SHOPS AT MERIDIAN RANCH CONVENIENCE STORE

LOT 2, THE SHOPS FIL. NO. 1A AT MERIDIAN RANCH

Grading & Erosion Control Plans

El Paso County, Colorado

EROSION CONTROL DETAILS

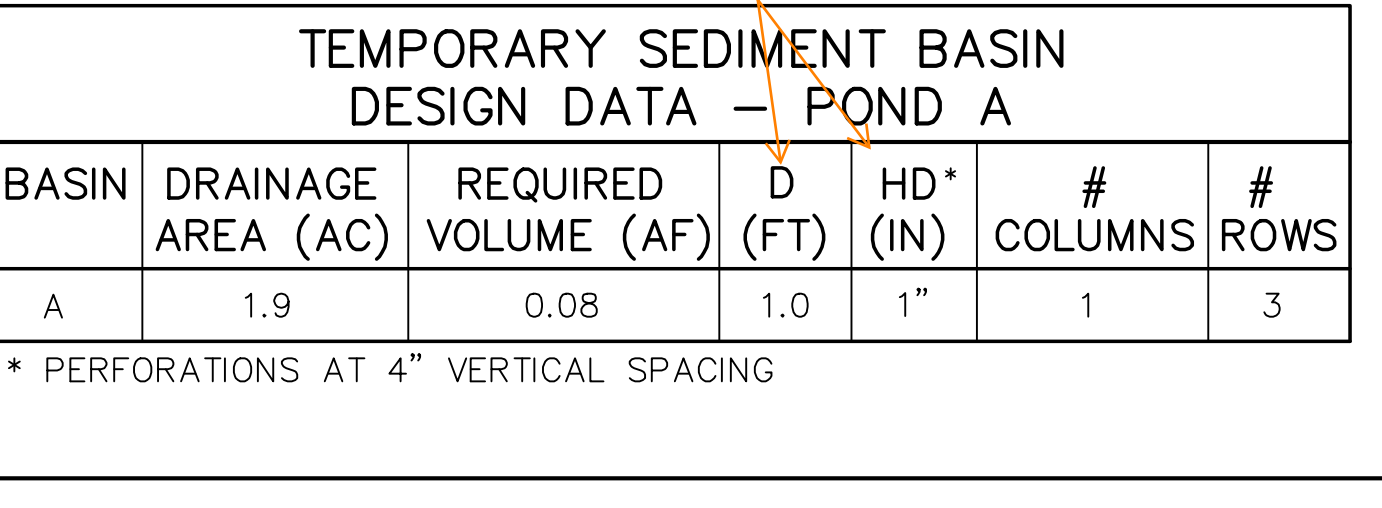
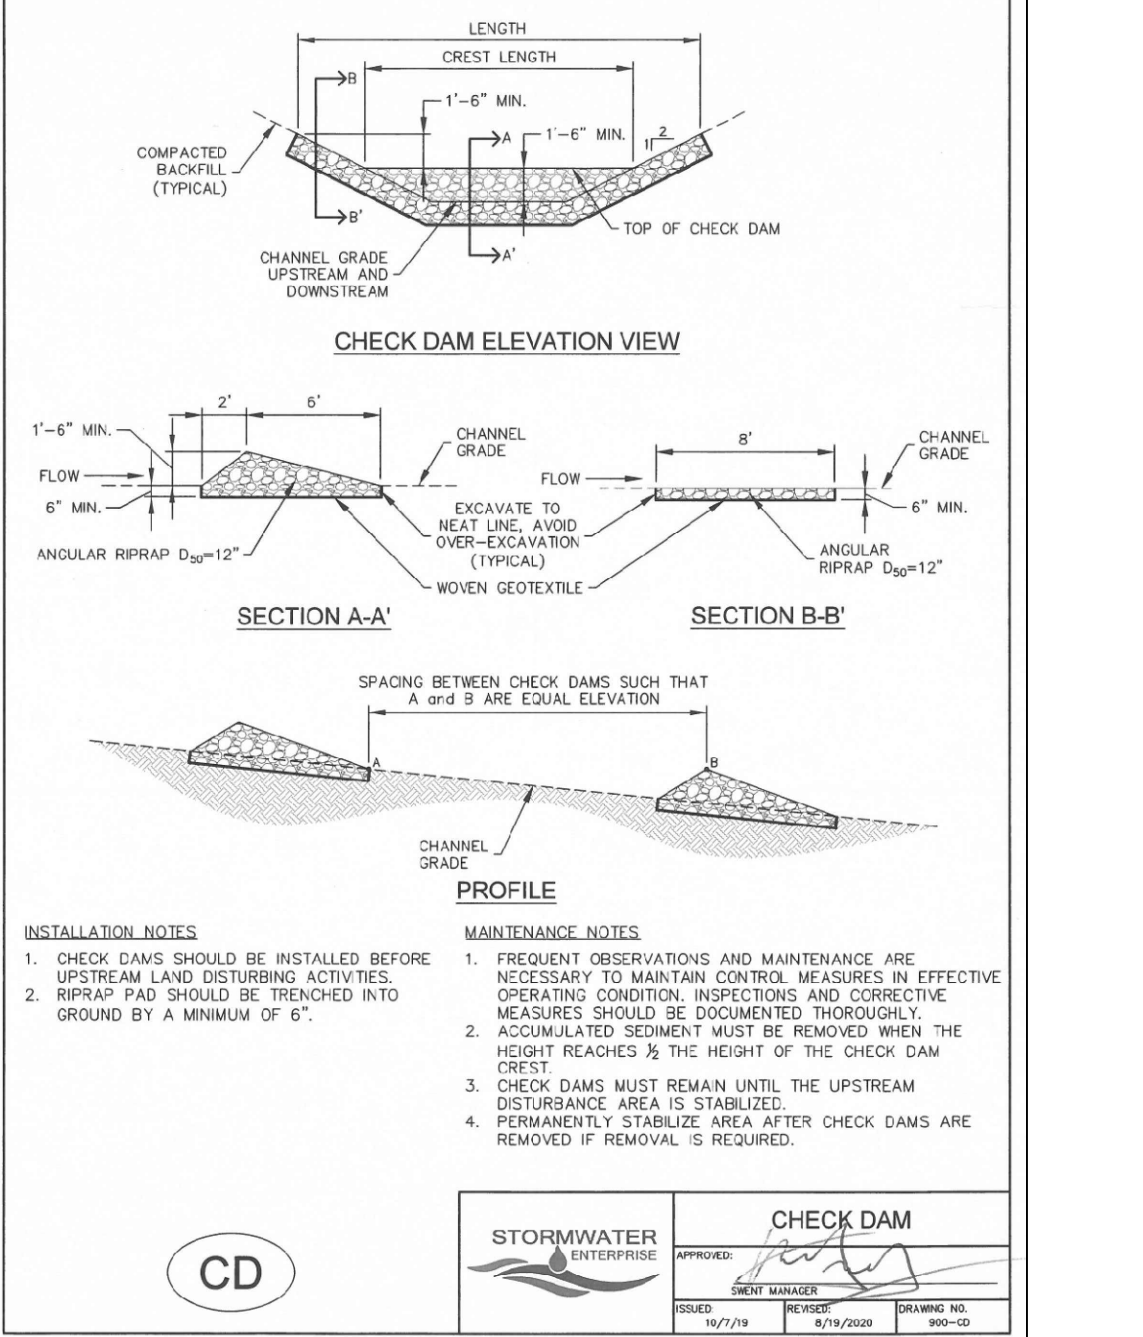
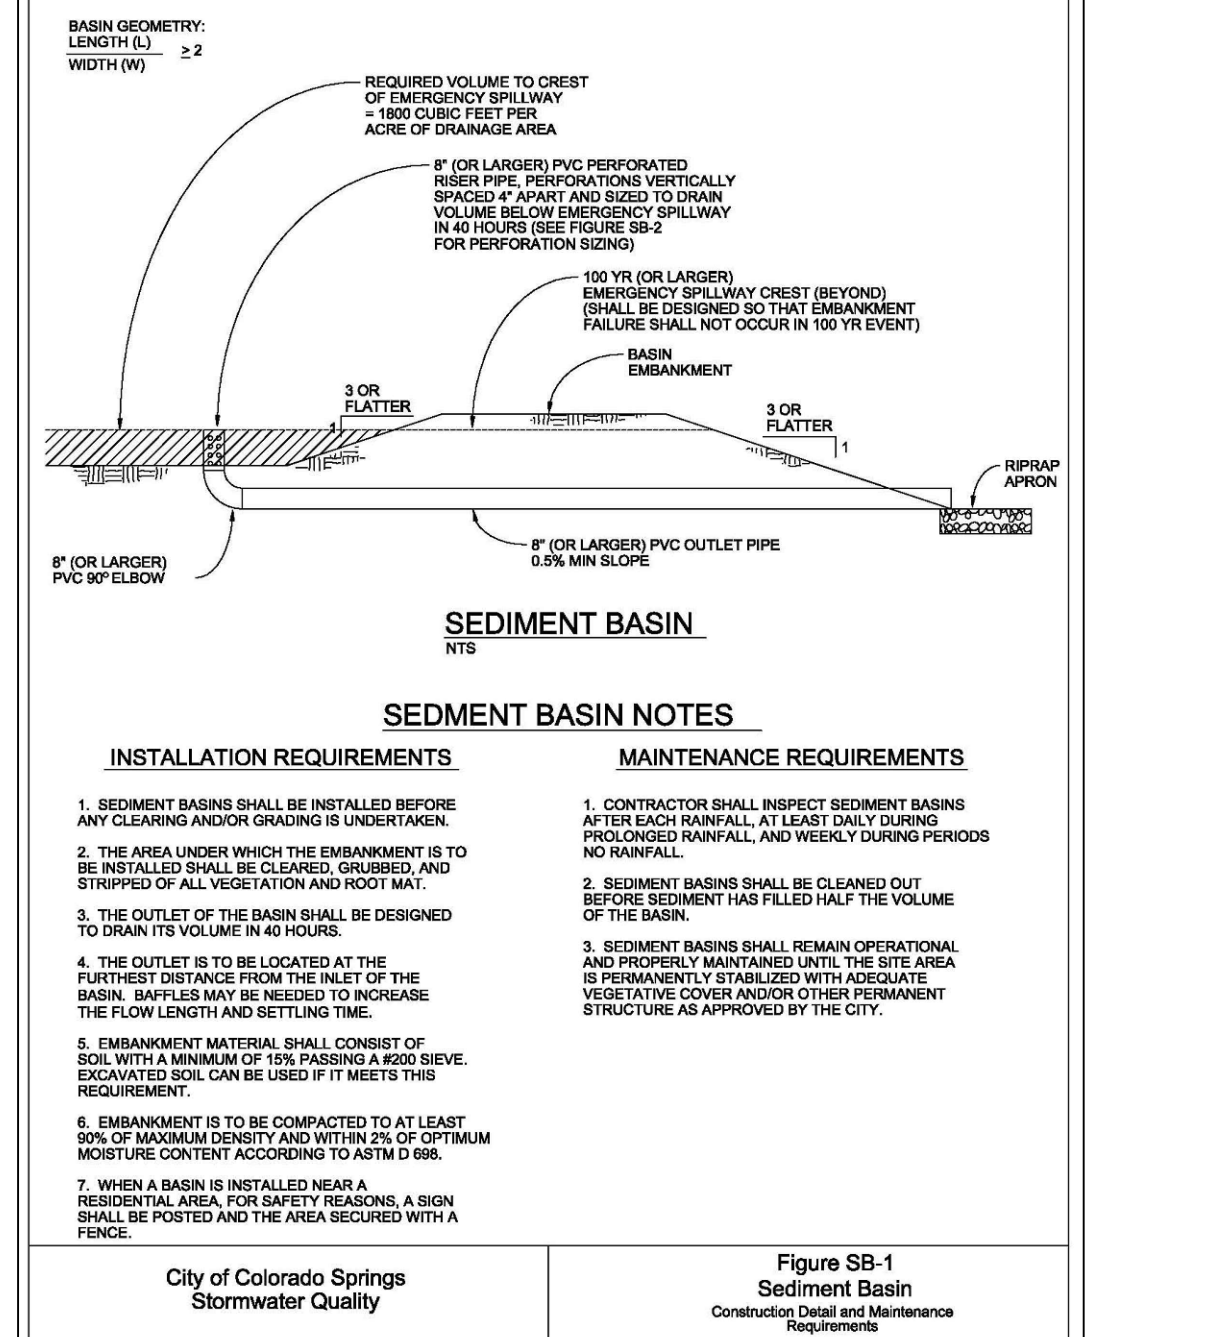
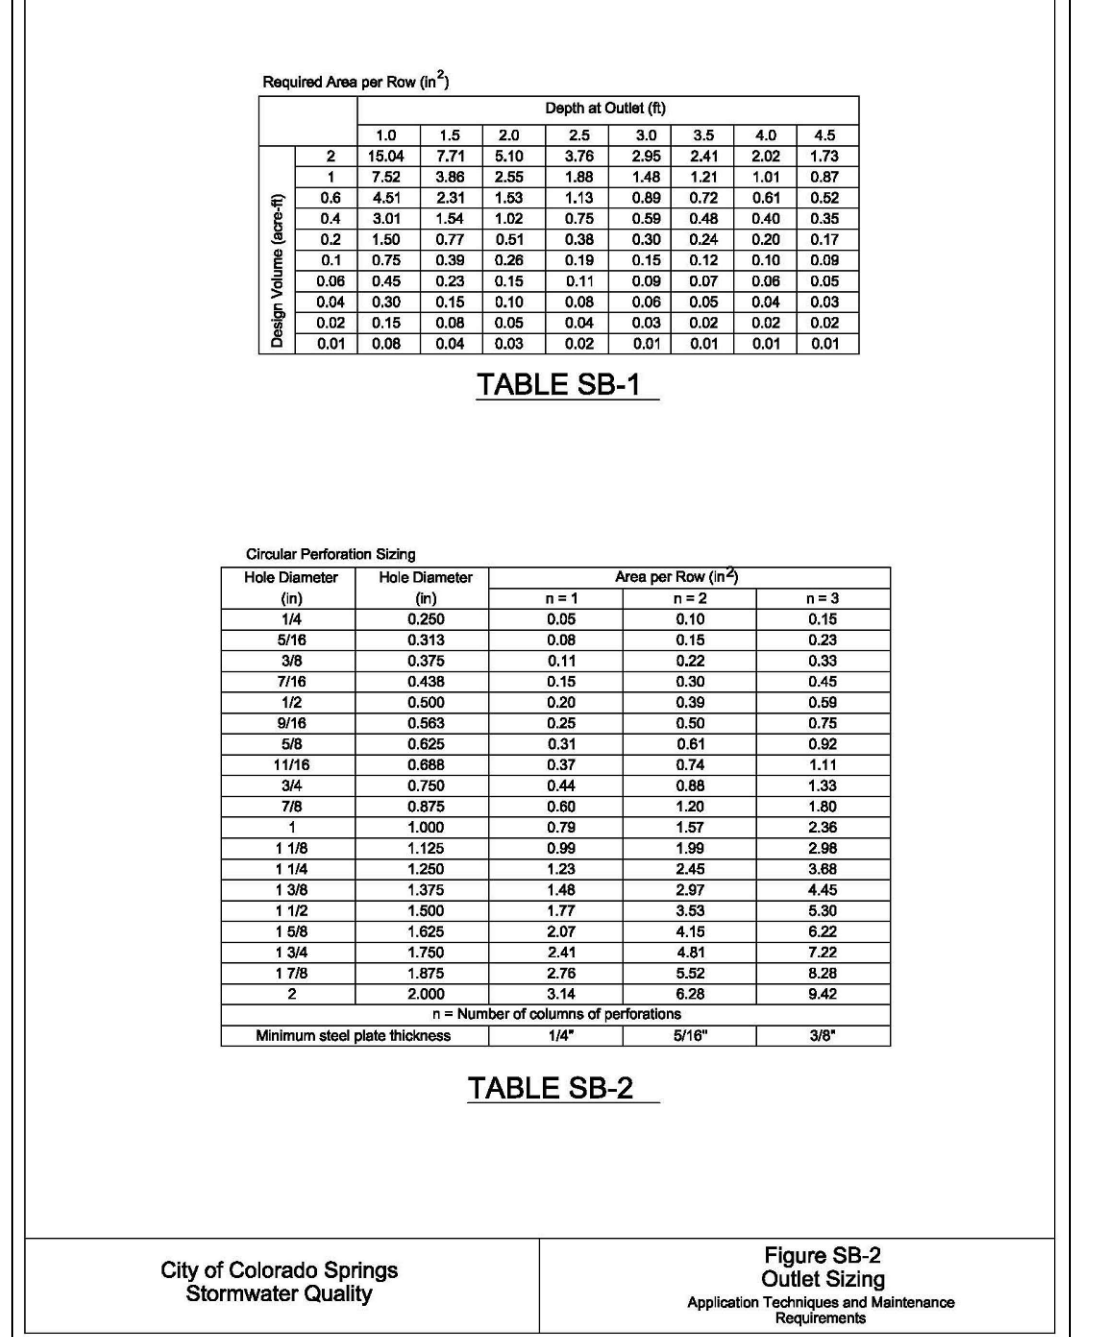
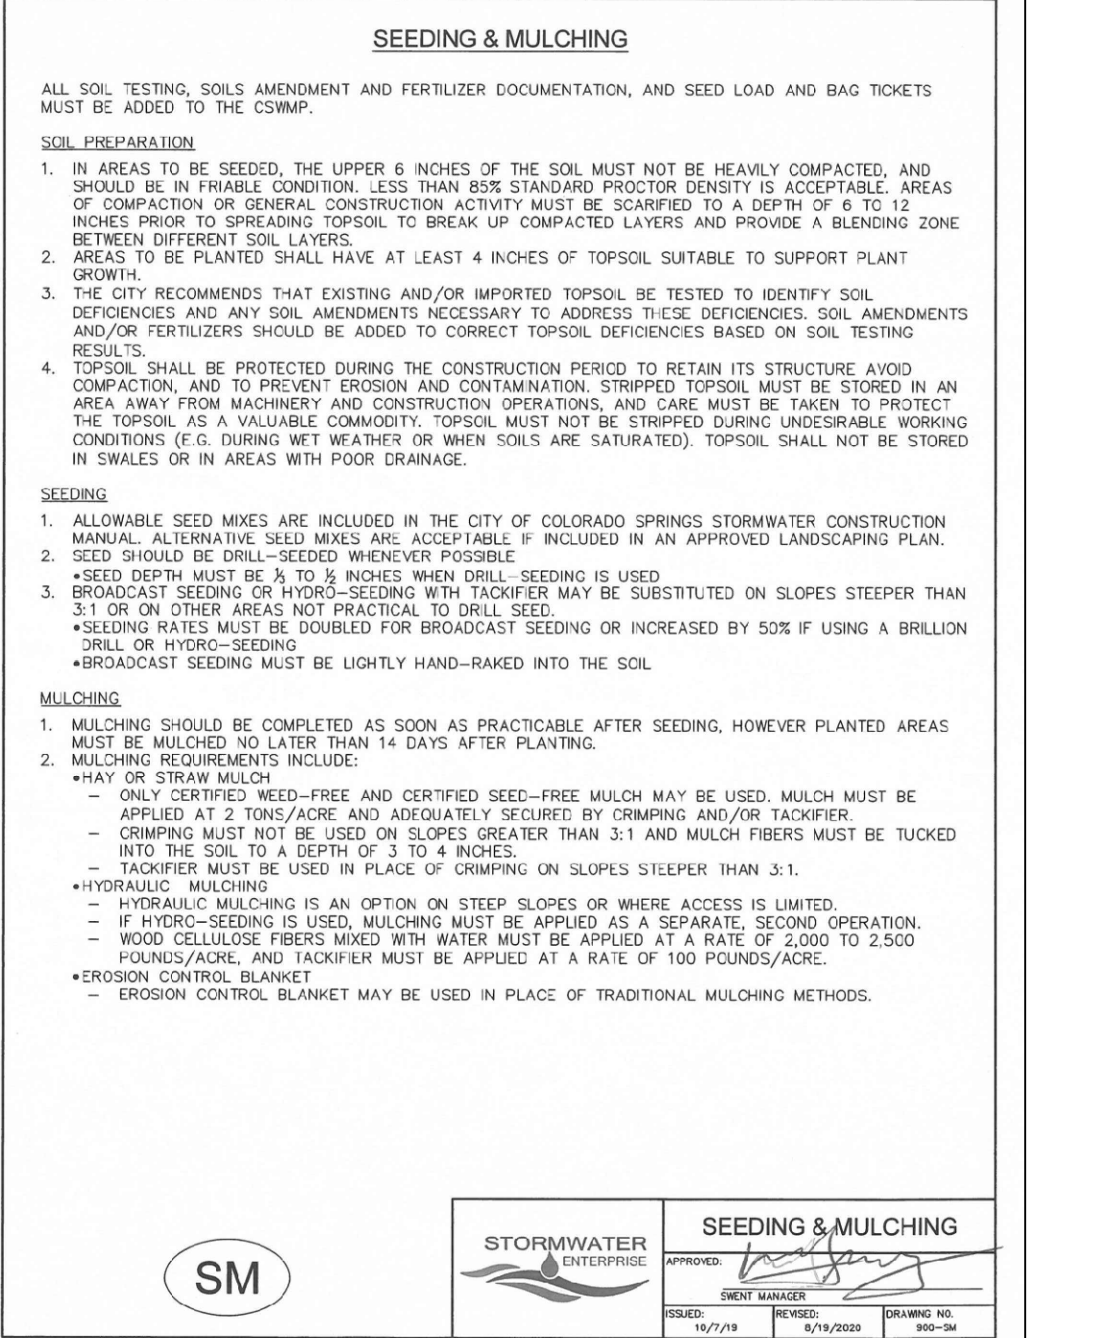
Provide sizing for spillway.

Define D and HD
